Applicant(s): BARLEV, Tuvia et al. Examiner:
Serial No.: 09/510,550 Group Art Unit: 2634
Filed: February 22, 2000
Title: HIGH SPEED ACCESS SYSTEM OVER COPPER CABLE PLANT

**PETITION TO WITHDRAW HOLDING
OF ABANDONMENT UNDER 37 CFR 1.181(a)**

DETAILED ACTION

FIG. 5

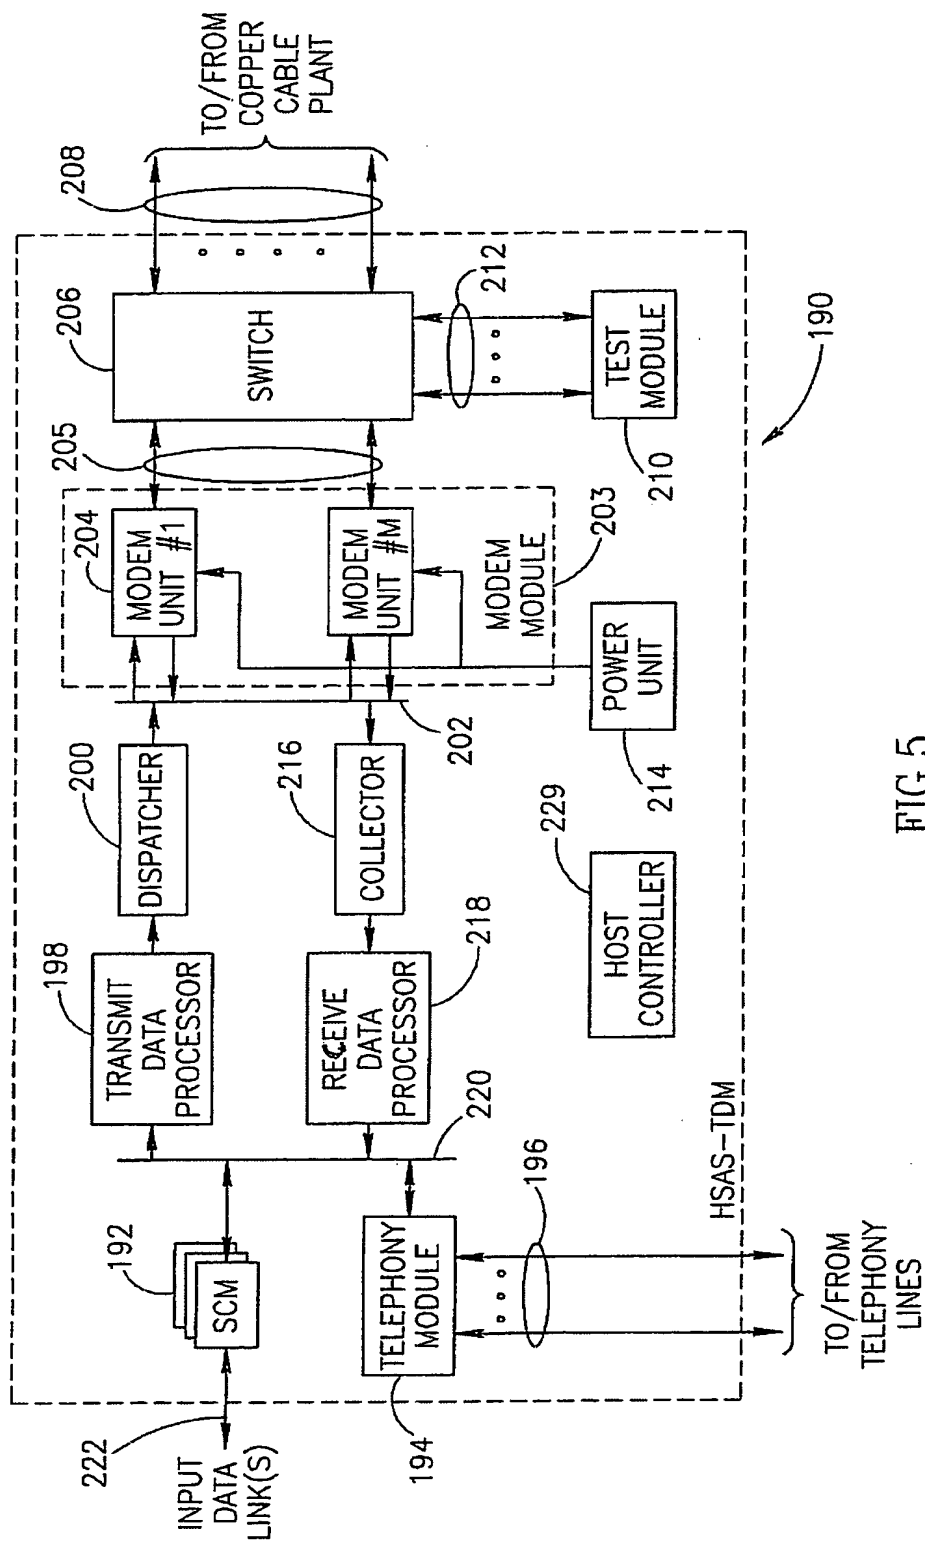
2. The drawings are objected to because in Figures 5 and 6, "REVEIVE" should be "RECEIVE" and in Figure 6, "TEST MODULE 256" should be "POWER SWITCH MODULE 256" in order to be consistent with page 27, lines 14, 19 and 27. A proposed drawing correction or corrected drawings are required in reply to the Office action to avoid abandonment of the application. The objection to the drawings will not be held in abeyance.

In Figure 5, in block 218, the text label "REVEIVE DATA PROCESSOR" was replaced with the text label "RECEIVE DATA PROCESSOR".

Figs. 5 and 6 have been amended to match the specification. The drawing sheets containing each corrected drawing are enclosed for review by the Examiner.

FIG.6

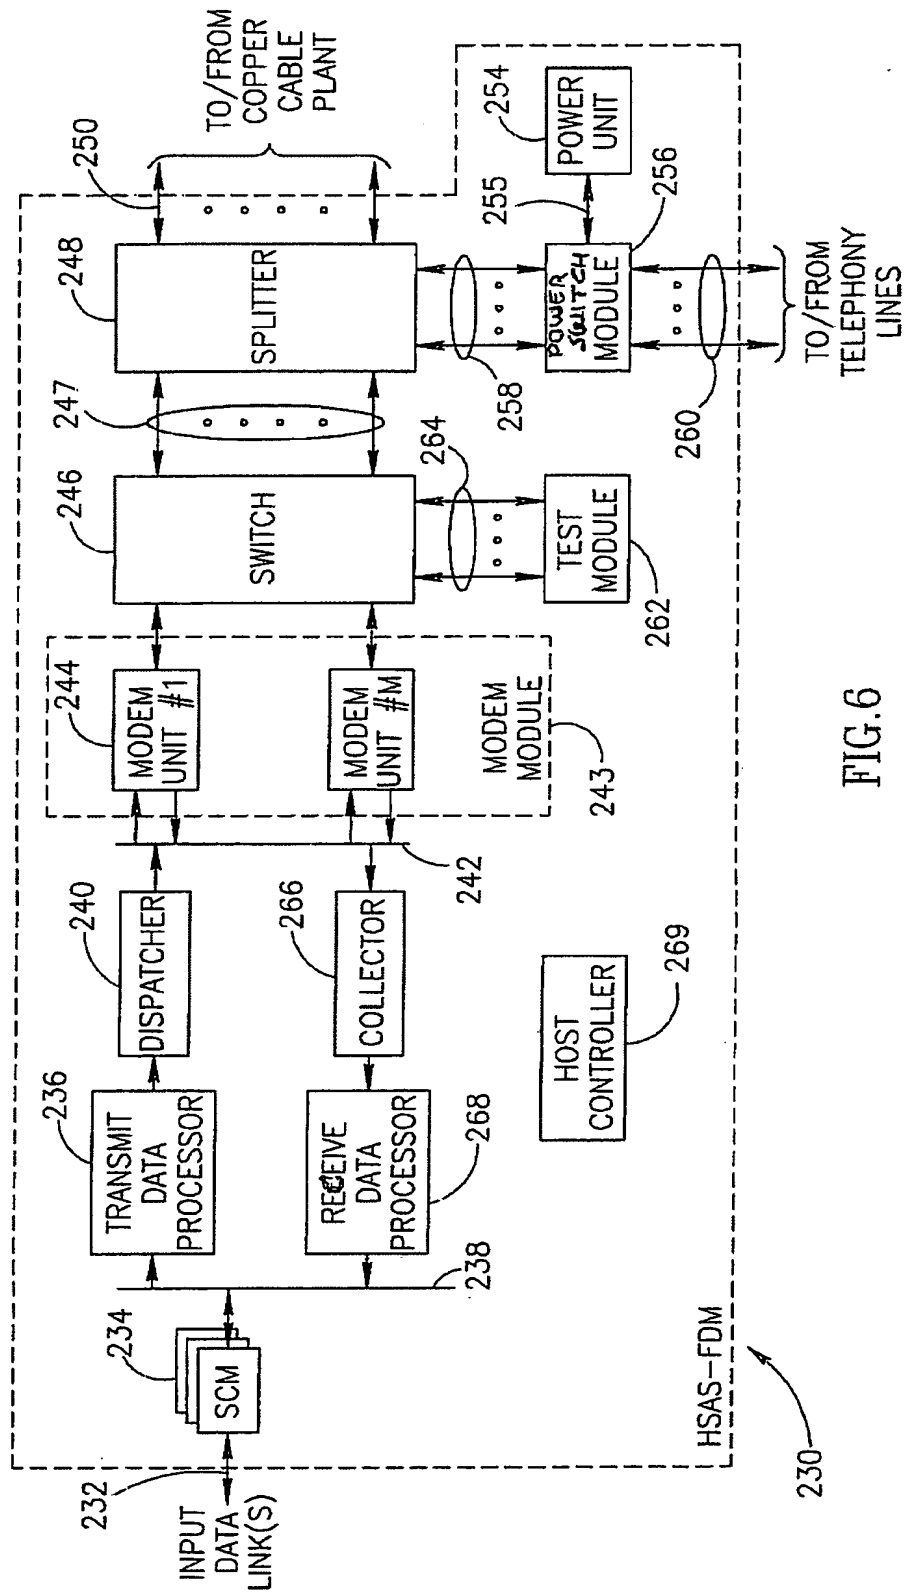
In Figure 6, in block 268, the text label "REVEIVE DATA PROCESSOR" was replaced with the text label "RECEIVE DATA PROCESSOR", and in block 256, the text label "TEST MODULE" was replaced with the text label "POWER SWITCH MODULE".
